#### Regulation No. 90 (Replacement brake linings)

### **Proposal for amendments to Regulation No. 90 (Replacement brake linings)**

#### **Submitted by the experts from the European Association of Automotive Suppliers\***

Paragraph 4.2.3., amend to read:

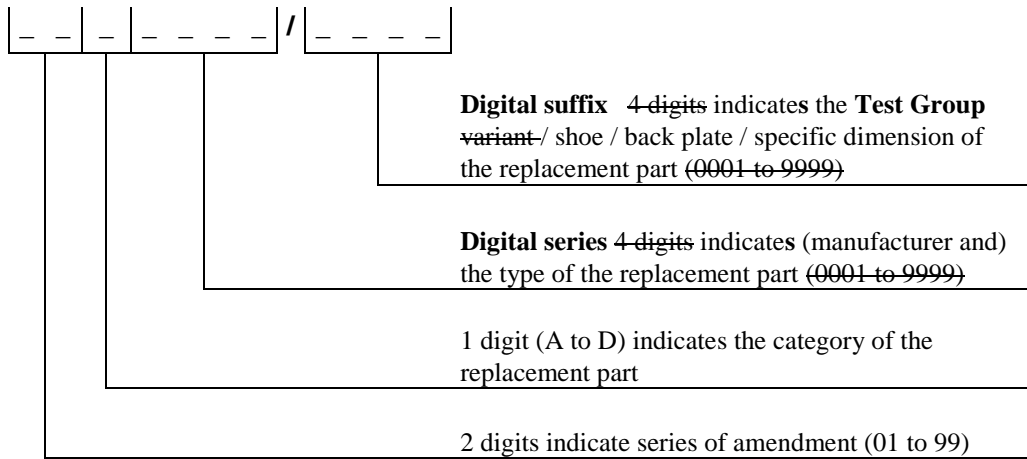
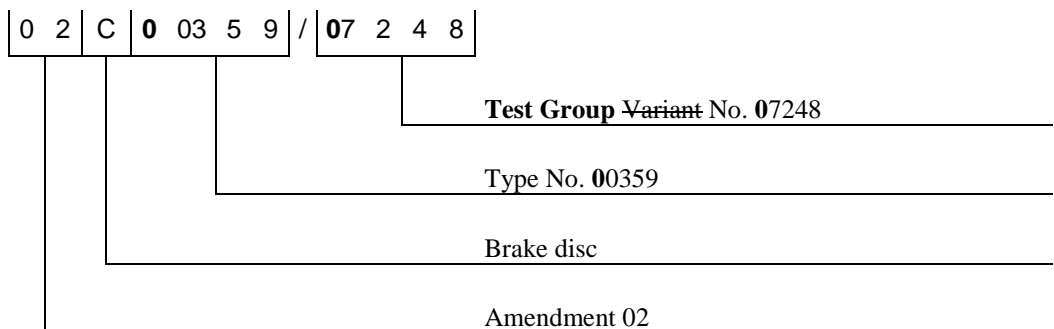
"4.2.3. The next ~~four~~ **series of** digits shall indicate the manufacture and the type of the brake lining, the type of disc or the type of drum.

**The digital suffix** ~~A suffix of four digits~~ shall indicate:

- (a) the shoe or back plate or specific dimension in the case of drum brake linings;
- (b) the **Test Group variant** in the case of a replacement disc or replacement drum.

**The variants approved as a Test Group shall be listed as an appendix to the approval document:**

Example:

1. As currently worded the approval of a Test Group requires individual certification for each part contained within the Test Group.
2. Some Test Groups can contain in the region of 30 part numbers.
3. The current wording thus increases the administrative burden and the consequent cost to the applicant of securing approval at no safety benefit to the consumer.
4. This was not the intention of the working group that drafted the extension to Regulation No. 90 and is different to brake linings where the approval of all parts contained within a Test Group are covered by a single certificate.
5. This proposal thus harmonises the system and practice for brake discs and drums with that for brake linings.

6. The restriction on the number of digits (4) used to define the Type and Test Group has been removed since the number of approvals issued has already exceeded 4 digits with some Approving Authorities.

7. The requirement for an appendix to the approval document listing the variants that have formed the Test Group has been added.
